Form C-103
 Revised July 18, 2013

Hilcorp Energy Company plans to recomplete the subject well in the Mesaverde formation and downhole commingle the existing Dakota with the Mesaverde. Attached is the MV plat and procedure. The DHC application will be submitted and approved before the work proceeds. A Closed Loop system will be utilized.

Morris Gas Com C #1E

Mesa Verde Uphole Recomplete

Vertical, Original Hole, 11/14/2018 3:32:28 PM

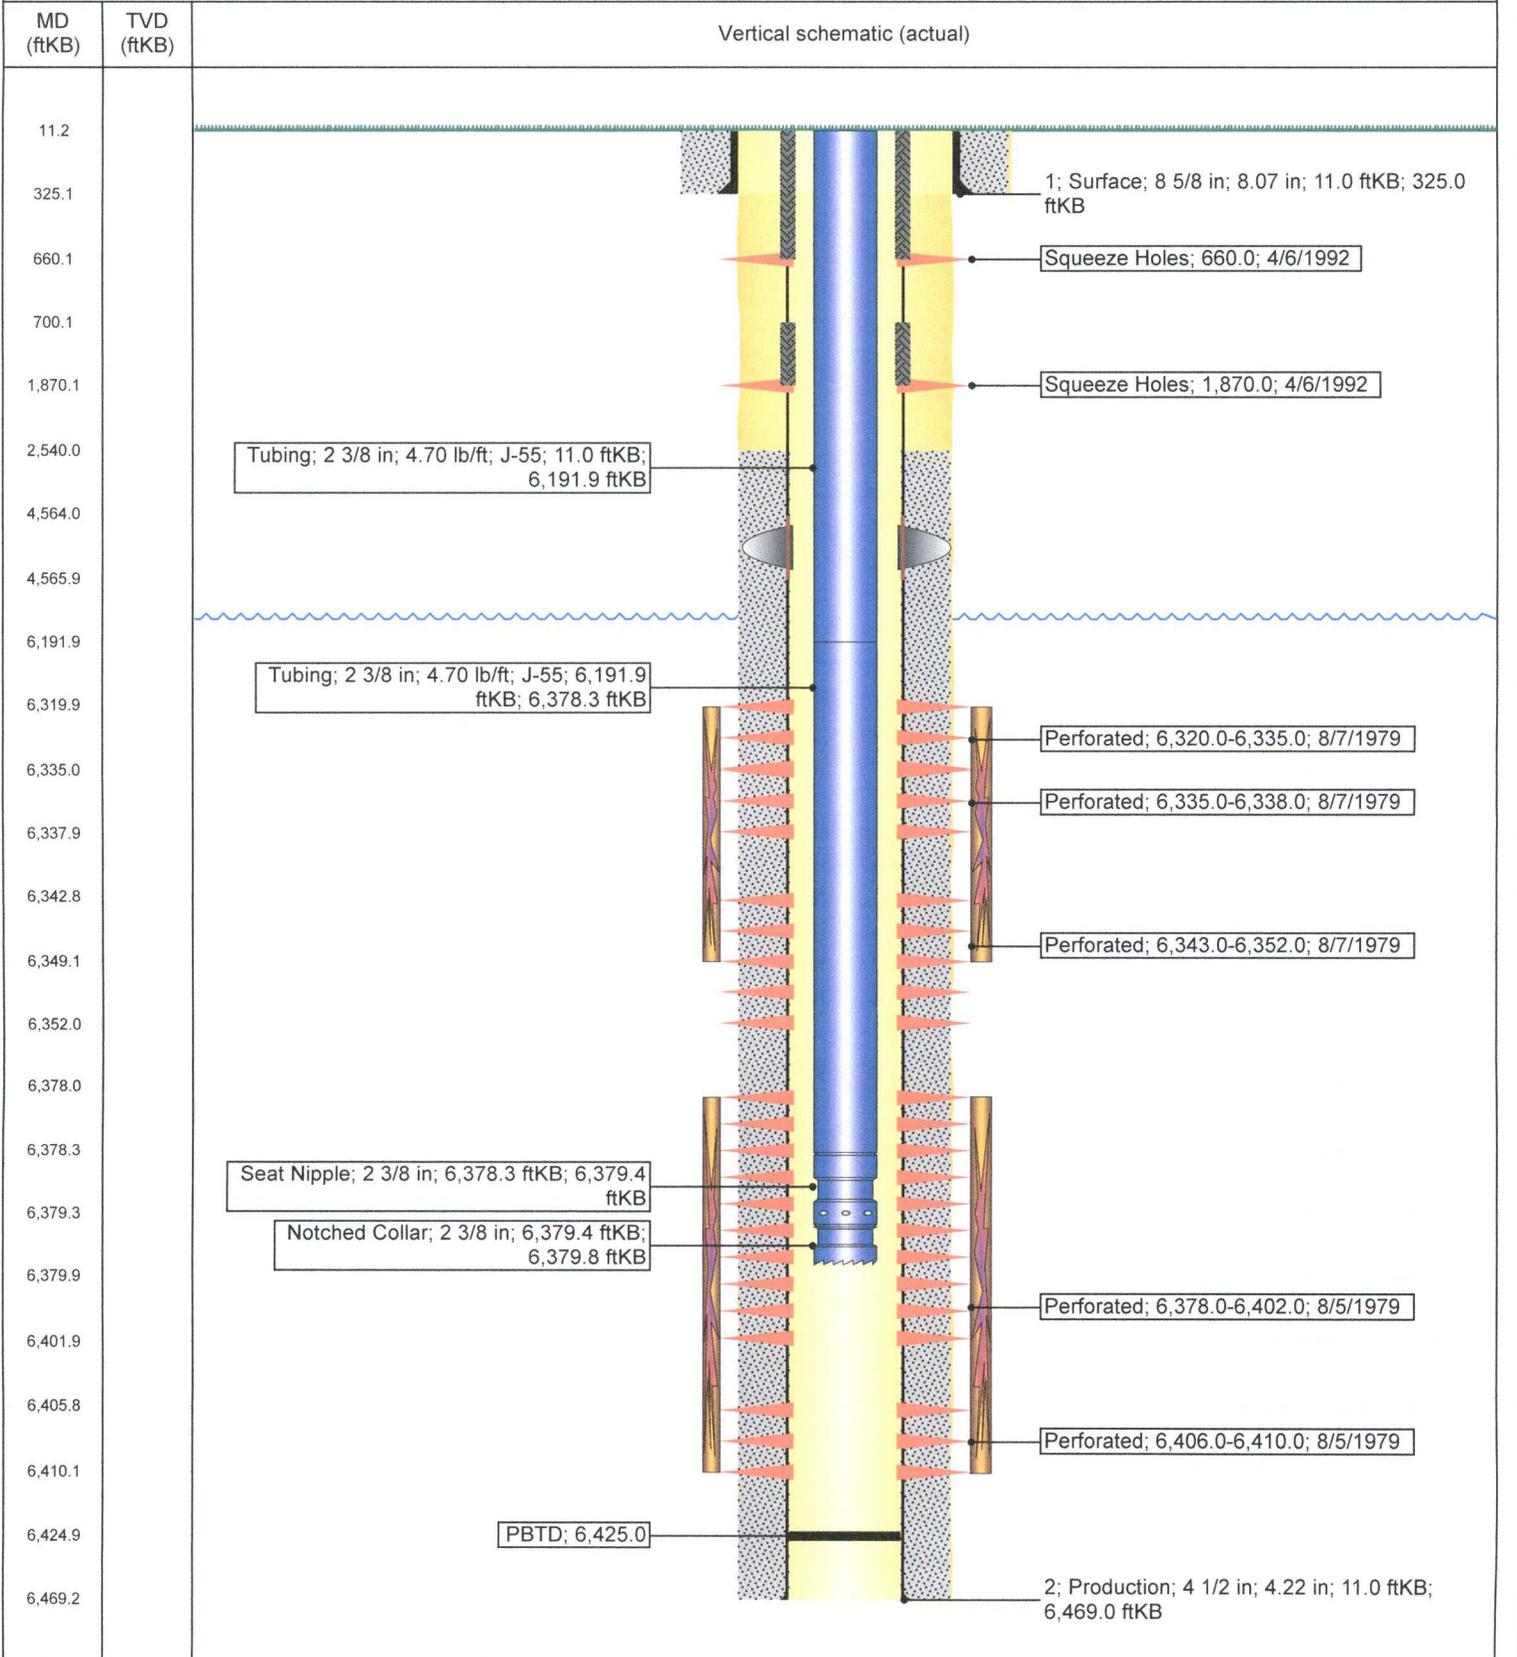
On the NOI for the Morris Gas Com C #1E can you please check with the engineers and email me the depth they plan on setting the CIBP. Also ensure future submittals have this information included in the procedure as without this information they are incomplete and may be denied.

They want to set it @ 4520', 100' below the proposed perforation. Please let me know if you need anything else.
